Groundwater Application Review Summary Form

Application # G- 19317

PUBLIC INTEREST REVIEW FOR GROUNDWATER APPLICATIONS

TO: Water Rights Section Date 7/30/2025
 FROM: Groundwater Section Phillip I. Marcy/Stacey Garrison
 Reviewer's Name
 SUBJECT: Application G- 19317 Supersedes review of 6/28/2023
 Date of Review(s)

Well Statistics

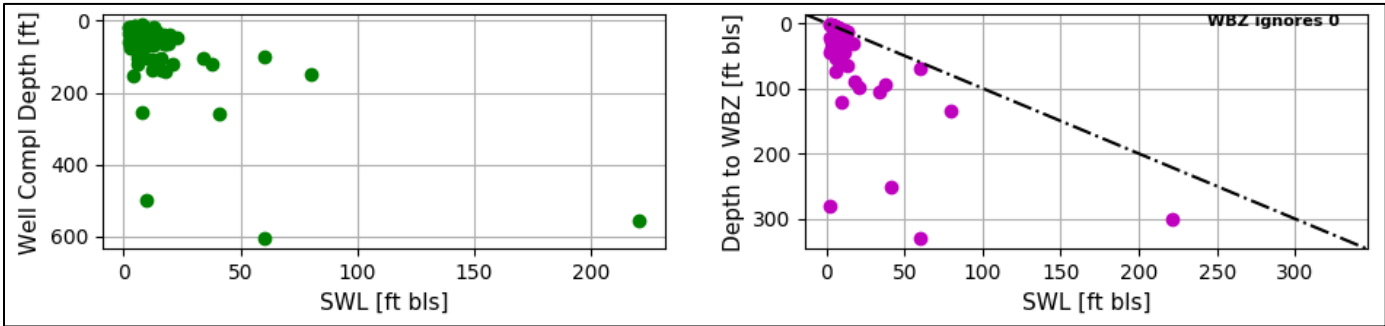
Statistics from wells constructed in this and surrounding sections report static water levels consistently above the depth of the water-bearing zone (WBZ) within each borehole, which suggests some degree of local confinement.
